Office of the City Manager

PUBLIC HEARING March 12, 2019

Subject: ZAB Appeal of 2701 Shattuck Avenue, Use Permit #ZP2016-0244

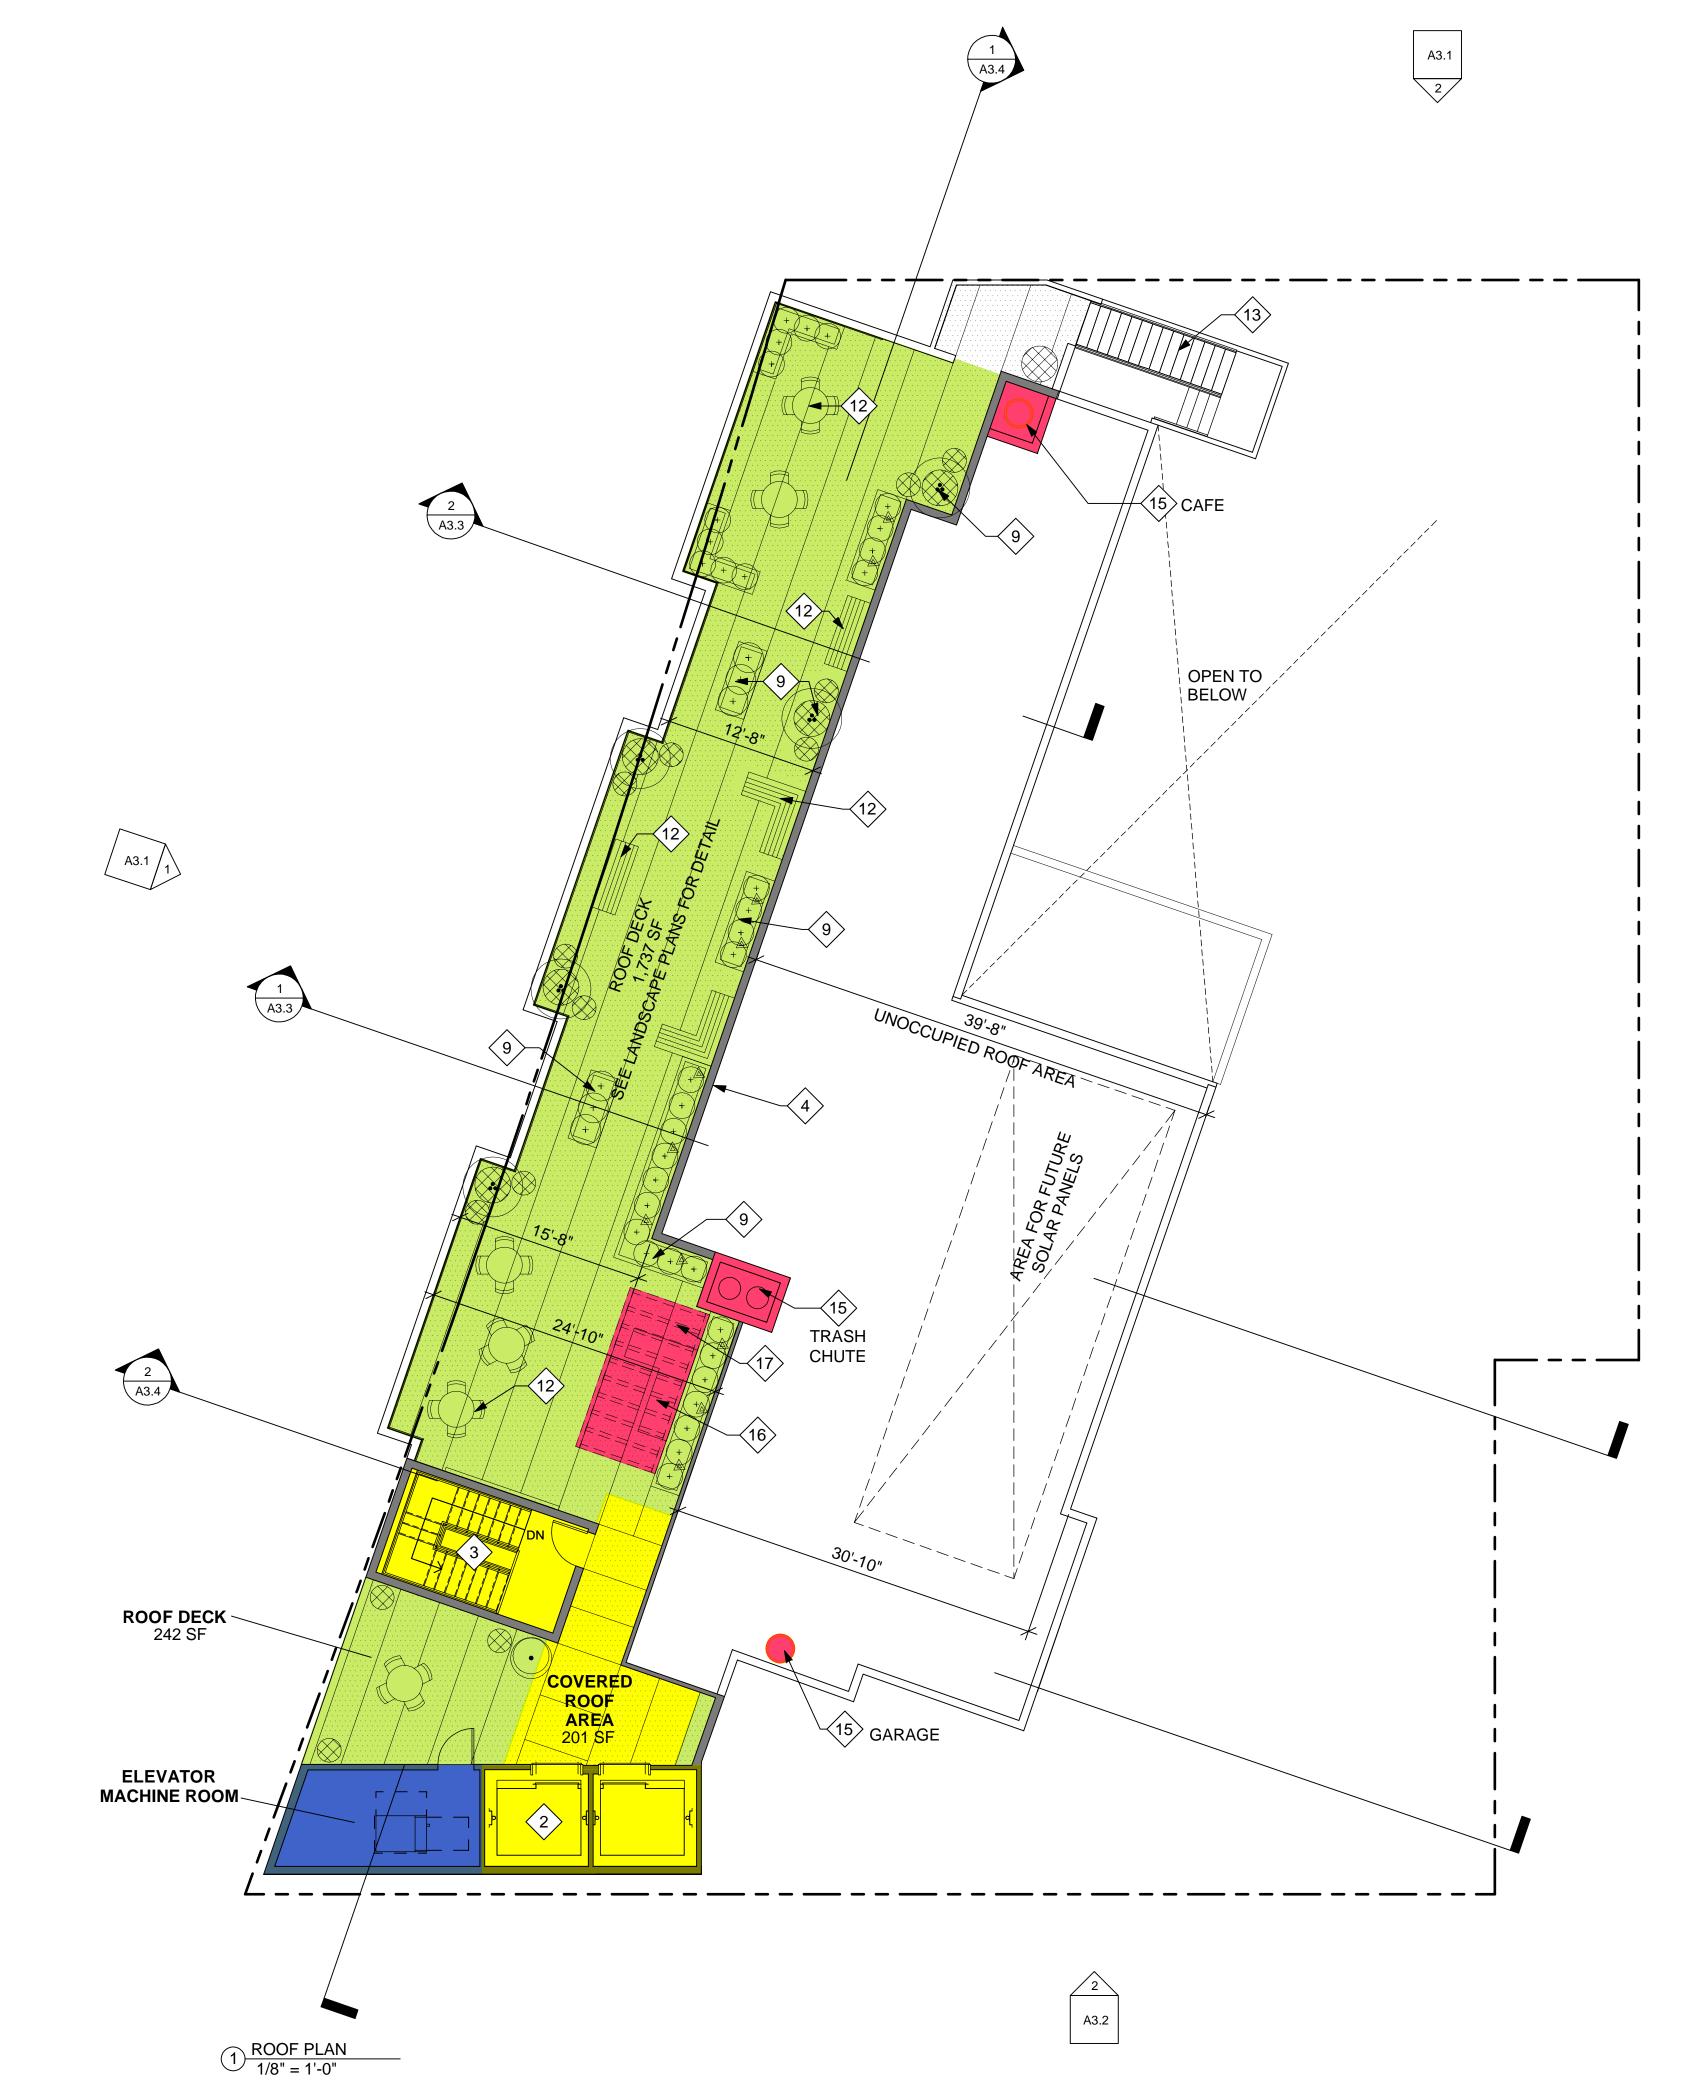
B. Move podium railing/parapet to the inside (west) edge of the planting beds so that the planting beds are east of it, to soften the wall edge; detail to be worked out at FDR. (Sheet A2.2)
